April 12, 1991
LD-91-016

Subject: Response to NRC Requests for Additional
Information

Reference: NRC Letter, I&C and Human Factors RAIs,
D. M. Crutchfield (NRC) to S. T. Brewer (C-E),
dated December 21, 1990

RESPONSE TO NRC REQUEST FOR ADDITIONAL INFORMATION
I & C AND HUMAN FACTORS BRANCHES

FIGURE 420.13
SIMPLIFIED BLOCK DIAGRAM
REACTOR TRIP
AND ENGINEERED SAFETY FEATURES
MANUAL ACTIVATION

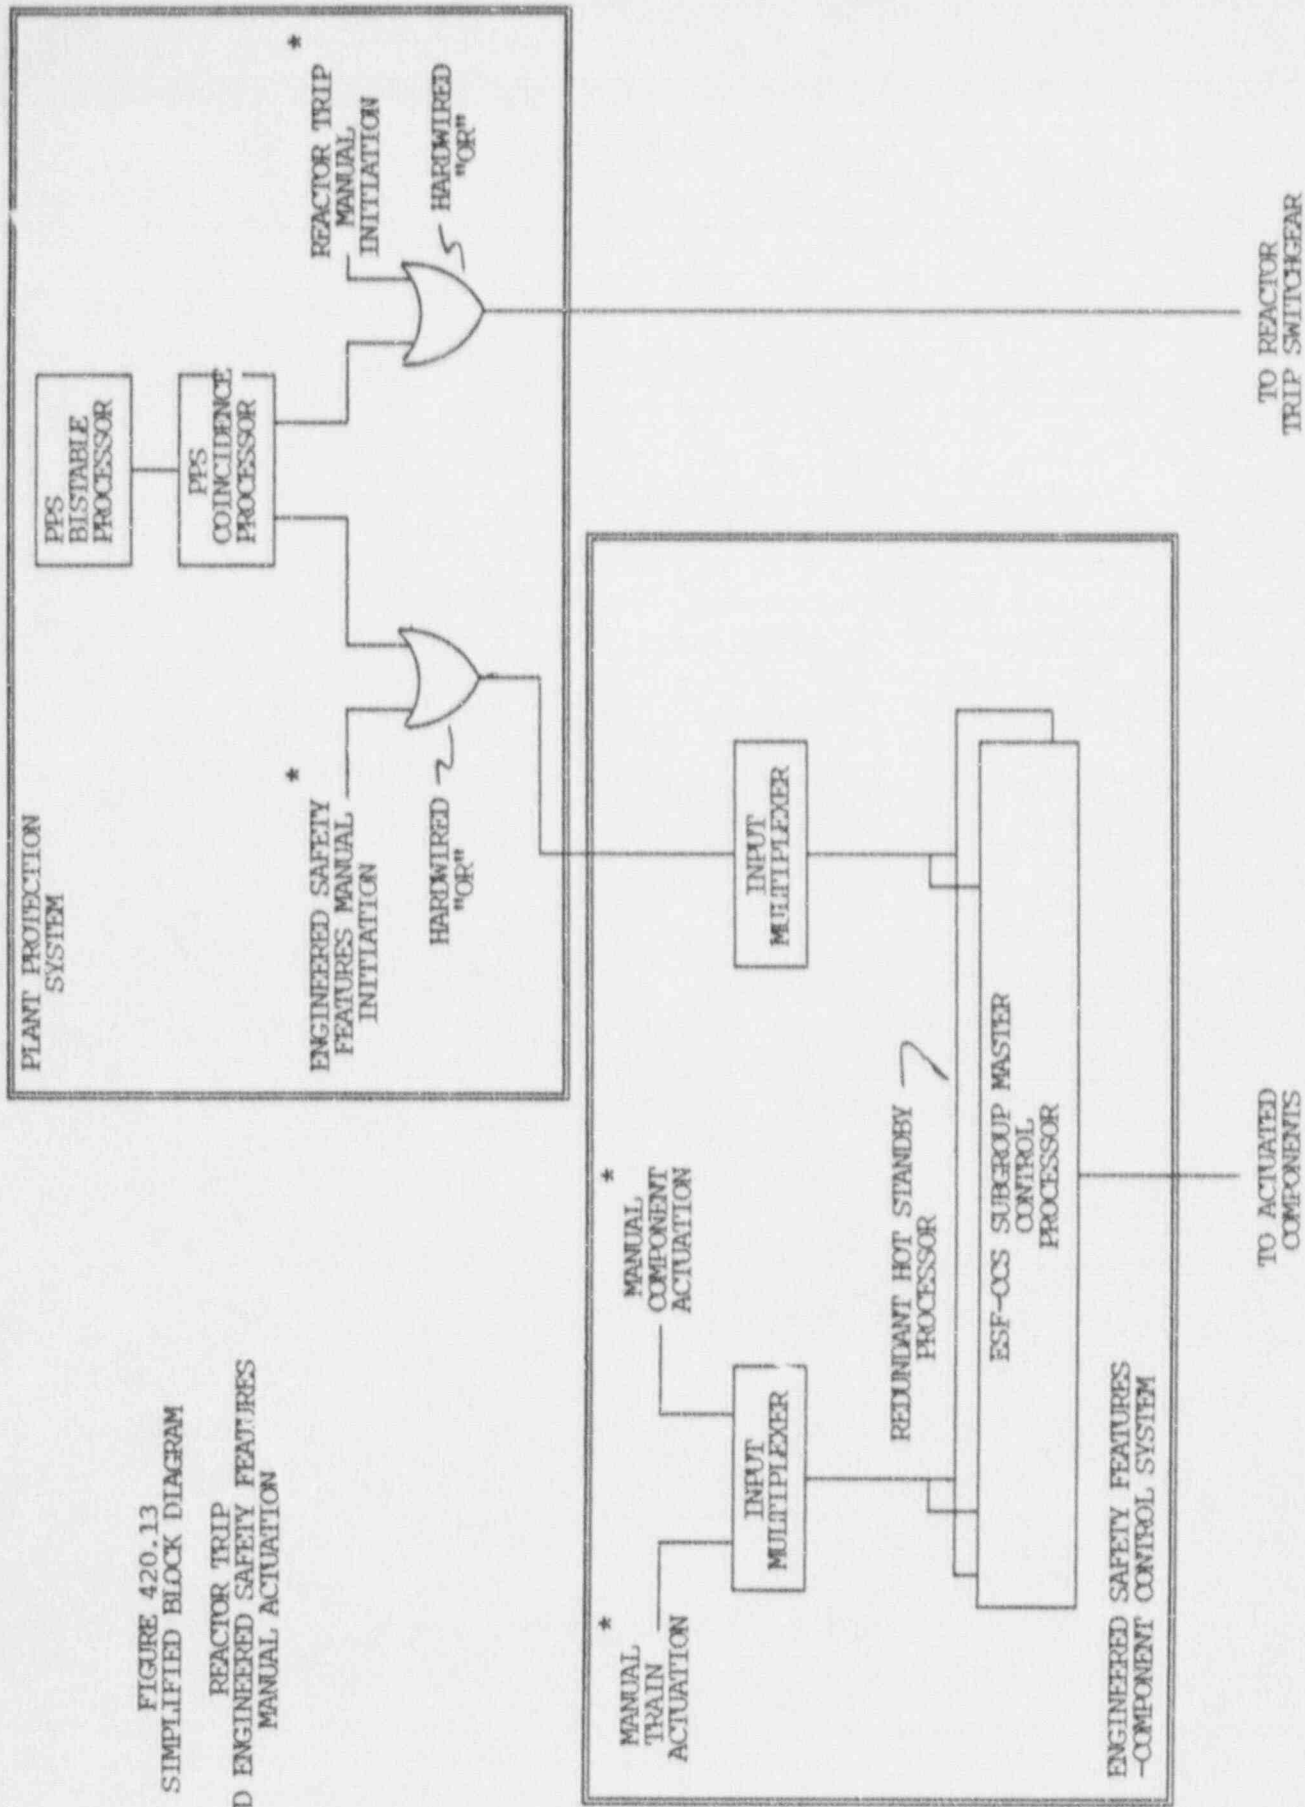
Question: As described in this section the amount of equipment common to automatic and manual initiation is to be minimized. Describe the equipment which is common. Are there any common hardware or software modules?

Response: The amount of equipment common to automatic and manual initiation is minimized.

Manual initiation of reactor trip and engineered safety features is shown in the simplified block diagram, Figure 420.13.

Reactor trip manual initiation is a hardwired function which interfaces with the reactor trip switchgear through hardwired circuits in the PPS cabinet. This manual initiation function does not rely on the use of computers to operate. The details of this circuit are shown in CESSAR-DC Figure 7.2-12 and Figure 7 of Appendix A of the PPS System Description, NPX80-IC-SD560*.

The only equipment common to all engineered safety feature initiation (automatic and manual) is the subgroup master control processor. This processor utilizes a redundant hot standby processor for increased reliability. To enhance software diversity train actuation (manual and automatic) and manual component actuation signals are processed in the software logic at different levels as shown in CESSAR-DC Figure 7.3-2.

NPX80+ PPS CH-A SIMPLIFIED BLOCK DIAGRAM
FIGURE 420.52

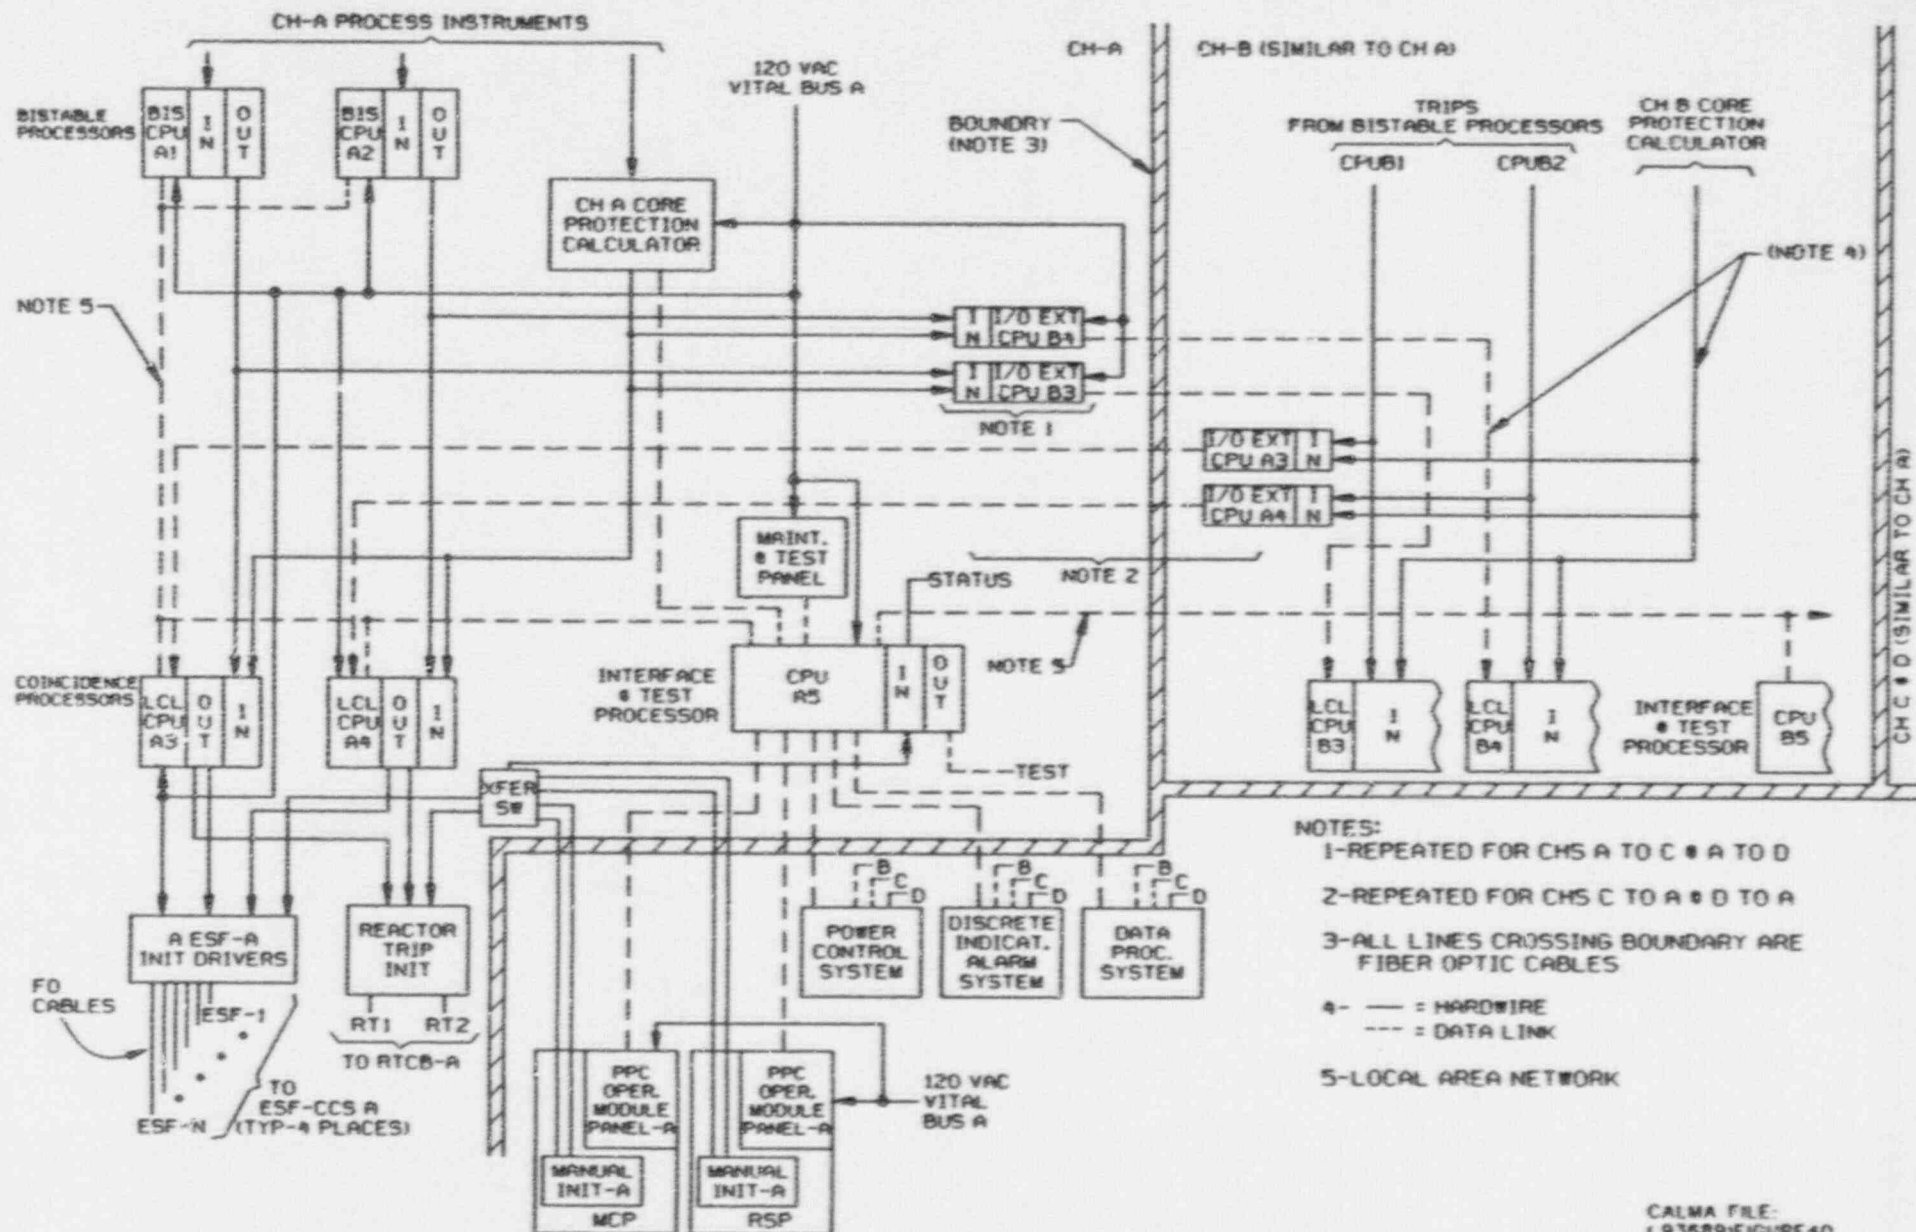
Number: 420.52 (Figure 7.2-12)

Question: Provide a detailed version of this diagram that shows individual power supplies, microprocessors, and connections. The staff understands that the details may change between this review and plant construction. As part of the "level of detail" discussions which are currently taking place, it would be helpful if C-E could provide their opinion, using the drawings as examples, of what should be "locked" into the design certification and what can be changed.

Response: Figure 7.2-12's primary purpose is to show (1) the two RTSG actuations, shunt trip and undervoltage, (2) that manual RT initiation is a hardwired interface to the RTSG, and (3) how the Alternate Protection System actuation devices are independent and diverse of the RSTG. This drawing depicts all of these features on a full system basis (i.e., four safety channels versus showing one safety channel and noting the other three are similar). The requested detail is more appropriately provided by Figure 2 of the System Description for Plant Protective System for Nuplex 80+ (NPX80-IC-SD560*). This figure is included here as Figure 420.52 with additions, as requested, to show application of the 120 VAC vital bus and power supplies for safety channel A. Discussion of connections, hardwire and data link, shown in the figure, can be found in NPX80-IC-SD560*.

PPS BISTABLE PROCESSOR FUNCTIONAL BLOCK DIAGRAM

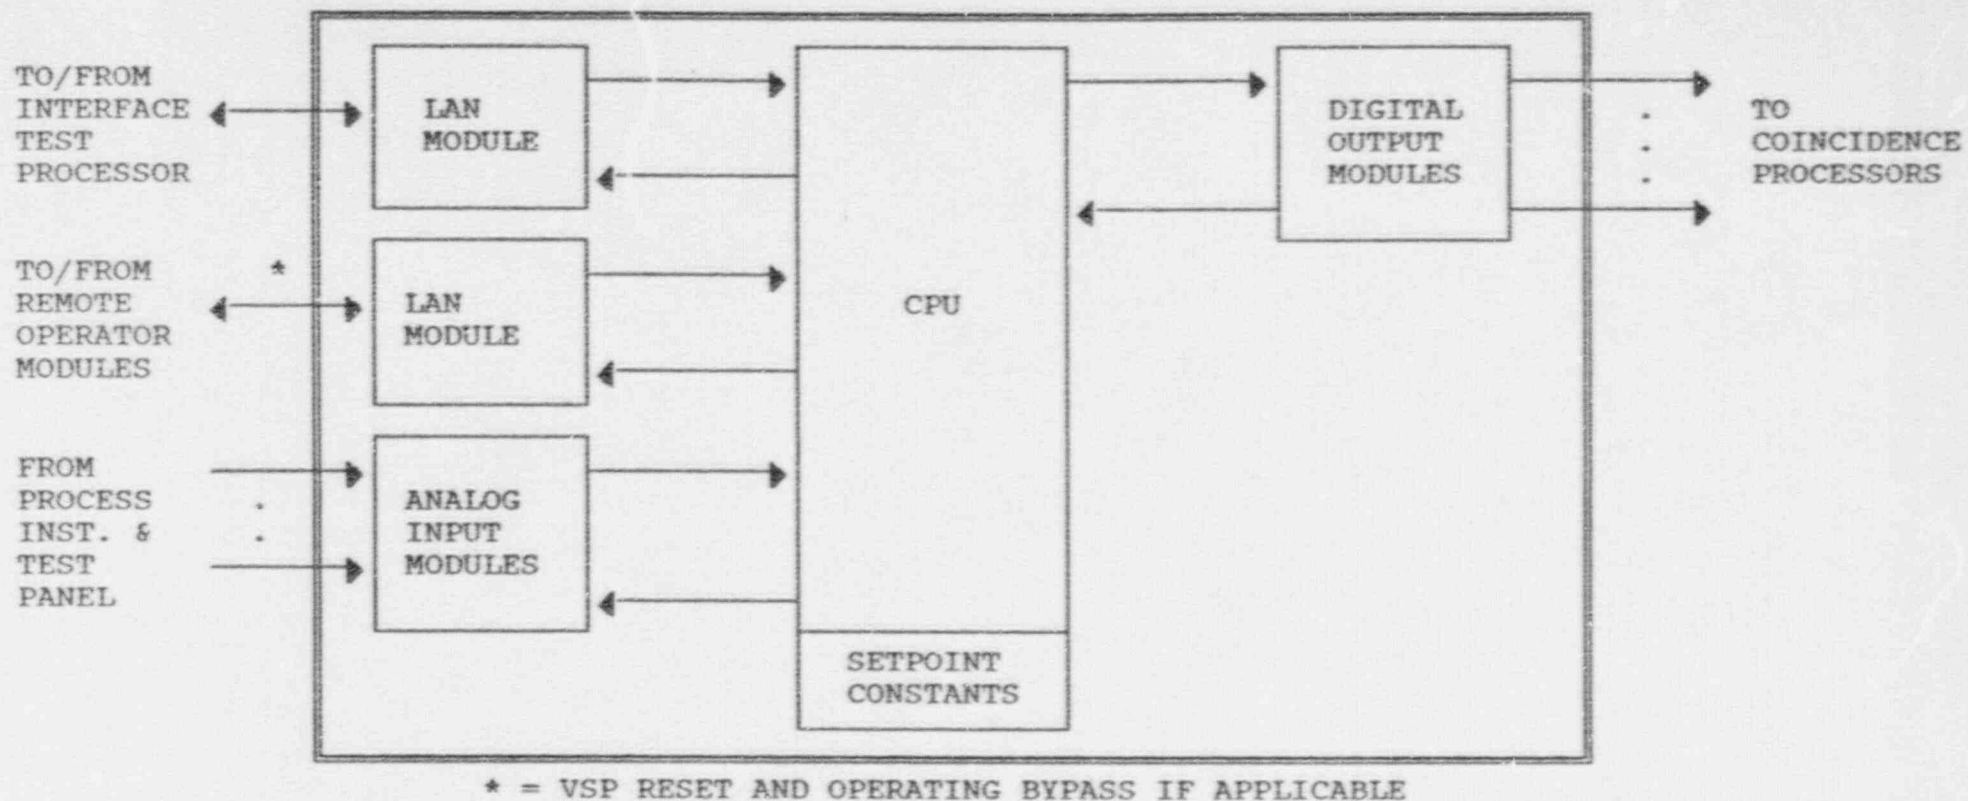
Number: 420.53 (Figure 7.2-11)

Question: It is unclear to the staff how the data flow through the functional blocks shown will actually be accomplished. Provide a more detailed figure.

Response: The attached Figure 420.53 is a block diagram of the bistable processor hardware. The analog input module converts the analog input signals (0-10 volt, 4-20 mA, etc.) to a binary number and stores them for use by the CPU. The CPU collects this data periodically as part of its execution cycle.

The bistable processor CPU uses the LAN modules to communicate with the Interface and Test Processor (ITP) within the PPS. The ITP transmits the variable setpoint reset and operating bypass enable states input by the operator at the remote operator modules. The bistable processor CPU executes logical functions in a fixed sequence as programmed in non-volatile memory. Included in the memory are setpoint constants (fixed setpoint values, variable setpoint reset offset values, rate limited variable setpoint rate and margin values, and allowable operating bypass range values. The CPU provides the calculated trip states (true or not true) to the digital output modules which are hardwired to the input multiplexors of the appropriate four redundant coincidence processors (one for each PPS safety channel). The bistable processor CPU also uses the LAN module to send its input data and calculated data to the ITP for display, alarm and test purposes. Another function of the LAN is to receive automatic test input signals from the ITP and to transmit test results status to the ITP.
